ARC REVIEW CODE: R1712181

TO: Mayor A. Max Bacon, City of Smyrna
ATTN TO: Ken Suddreth, Community Development Director
FROM: Douglas R. Hooker, Executive Director, ARC
RE: Development of Regional Impact (DRI) Review

Name of Proposal: Emerson Center (DRI 2764)

DRI SITE PLAN
EMERSON CENTER
LAND LOTS 880 & 881
17th DISTRICT, 2nd SECTION
COBB COUNTY GEORGIA

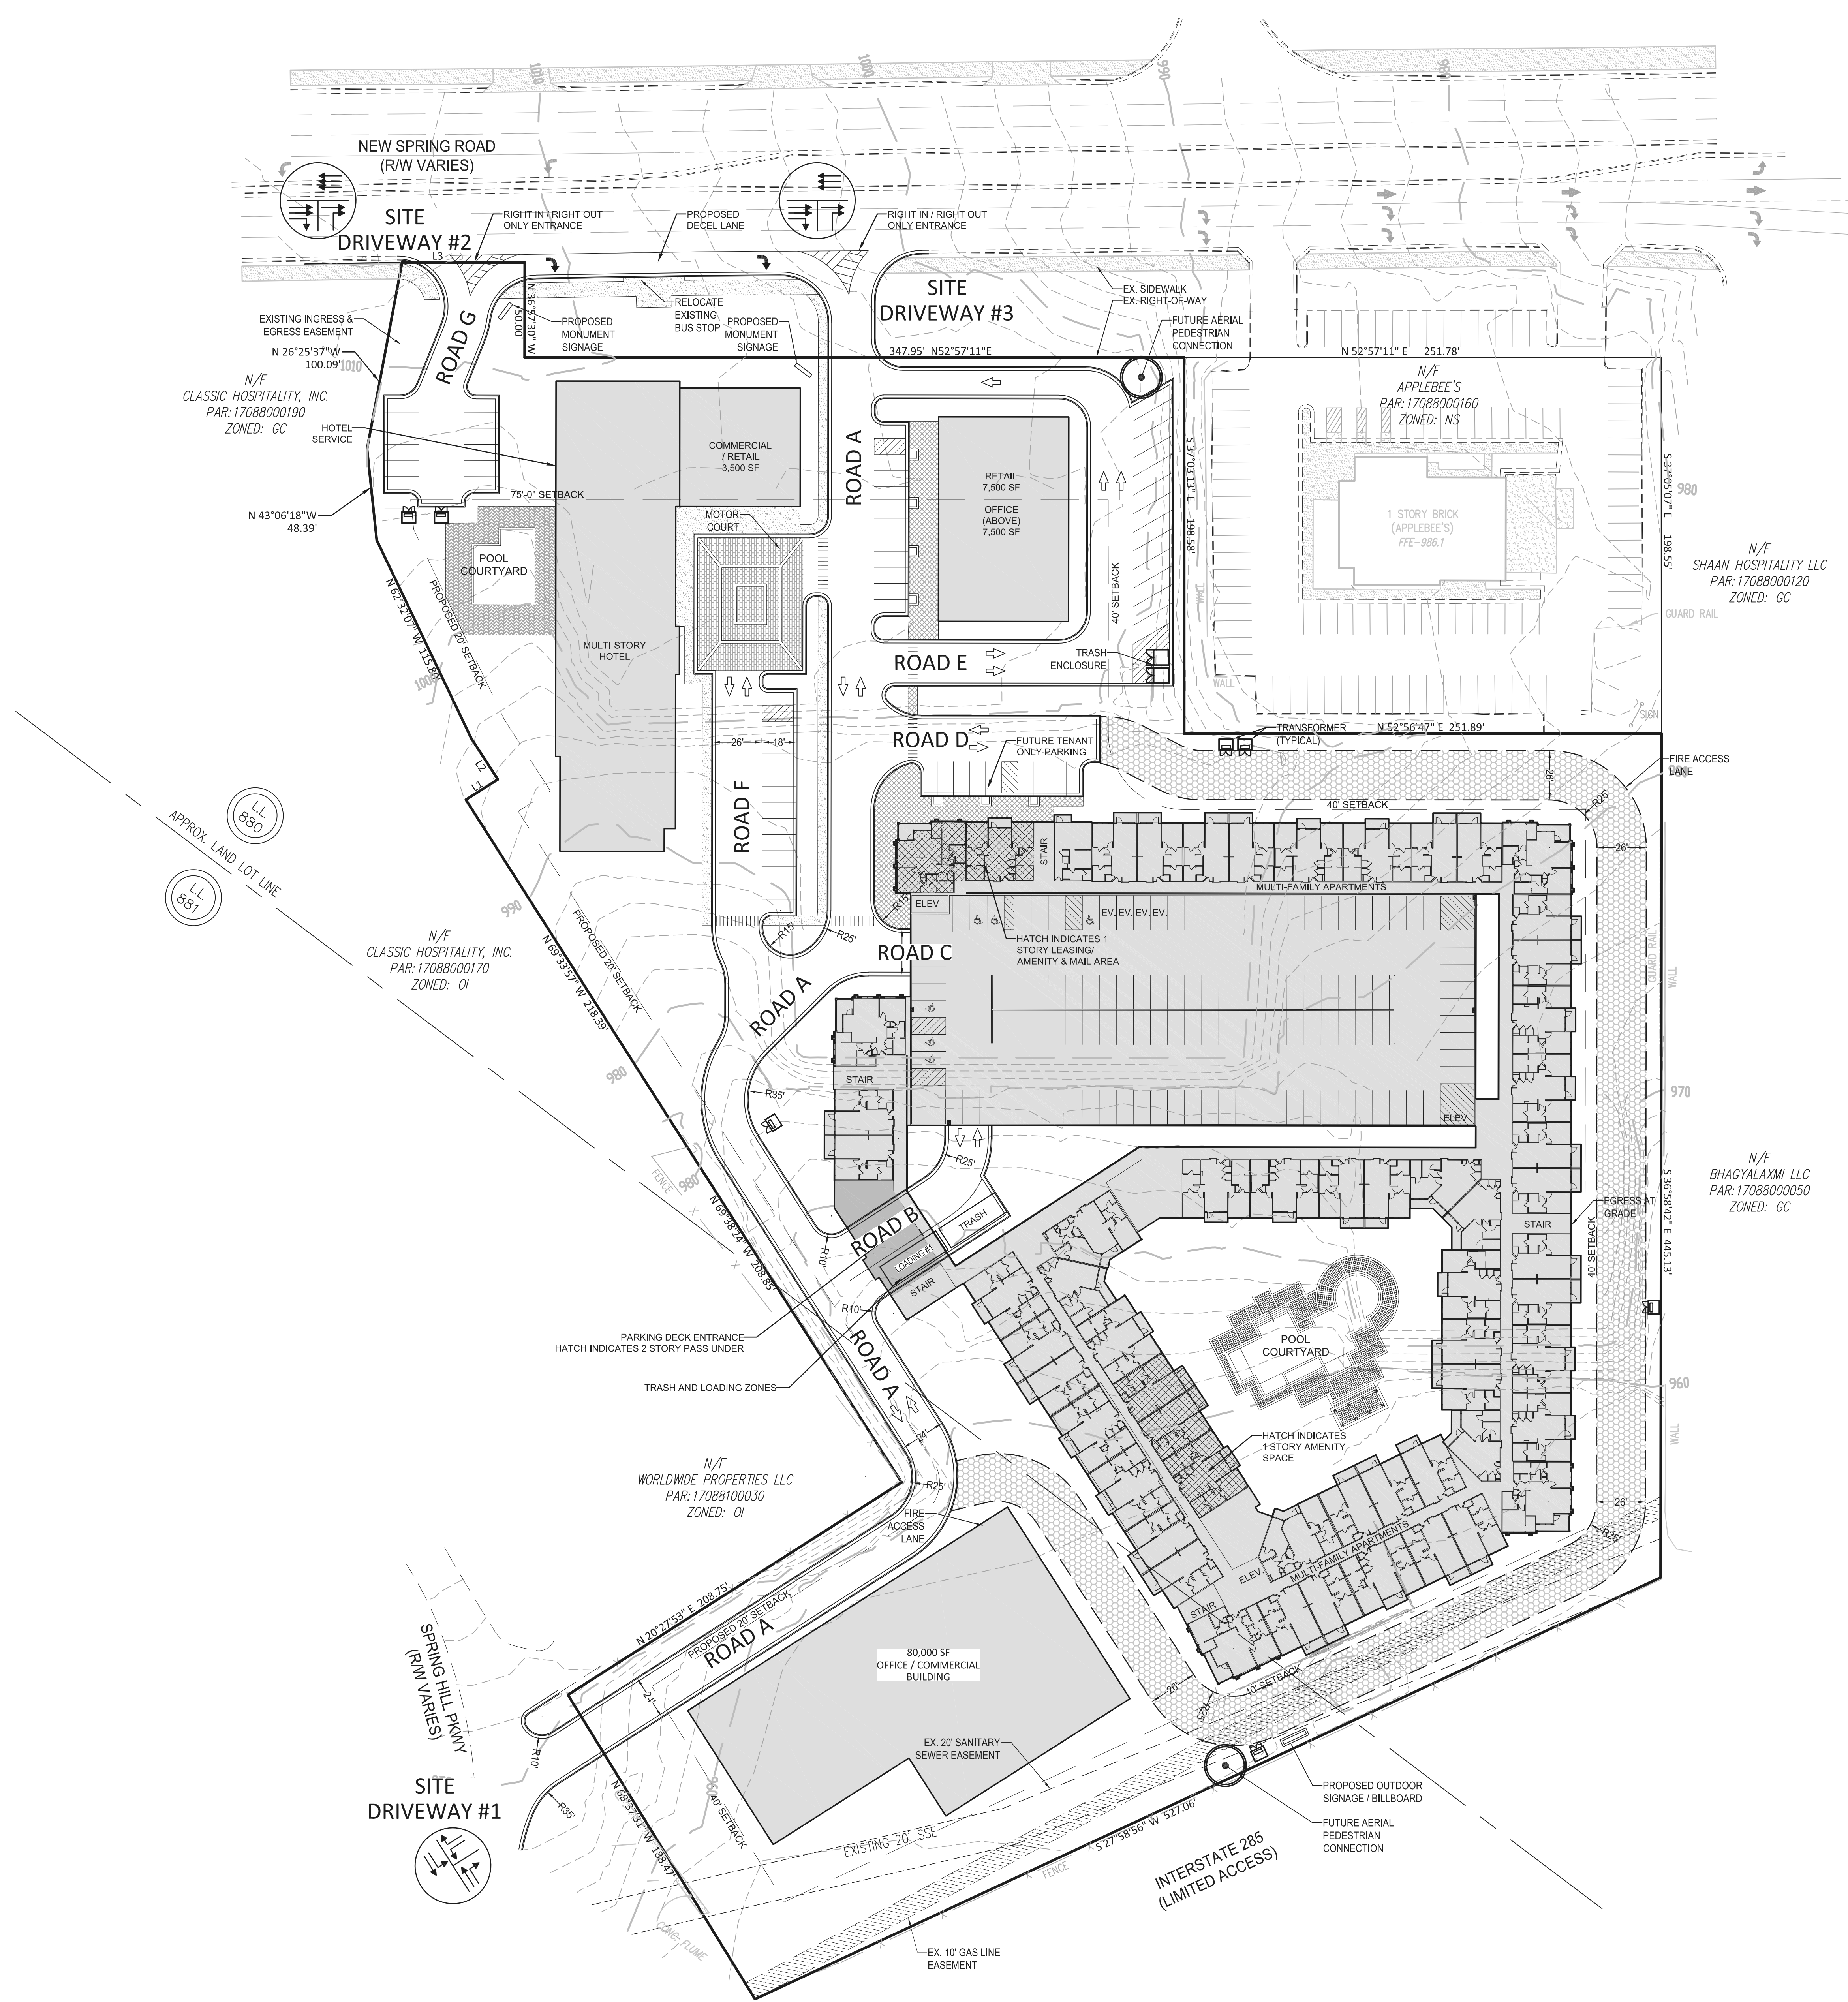
Along those lines, care should be taken to ensure that the development promotes a functional, safe, clearly marked and comfortable pedestrian experience on all streets, paths and parking areas. Especially given the opportunity for district-wide connectivity via the two pedestrian bridges indicated on the site plan, ARC recommends that the development team reconsider how best to accommodate north-south pedestrian circulation internal to the site. Sidewalk access appears to end just south of the hotel at the Road C entrance to the parking structure for the multifamily component. Sidewalks do not appear to connect

directly to either of the future aerial pedestrian walkways. The development team is also encouraged to ensure that end-of-trip facilities (bicycle racks, etc.) are provided for residents, workers and visitors at key locations throughout the site. The project could further support The Atlanta Region's Plan in general if it incorporated other aspects of regional policy, including green infrastructure and/or low-impact design (e.g., rain gardens, vegetated swales, etc.) as part of any improvements to streetscapes, driveways, parking areas, buildings, etc.

The site plan does not provide specific information or depictions of bicycle and pedestrian facilities. While there are opportunities vis site design to provide connectivity to adjacent parcels, the site plan does not show any proposed connections.
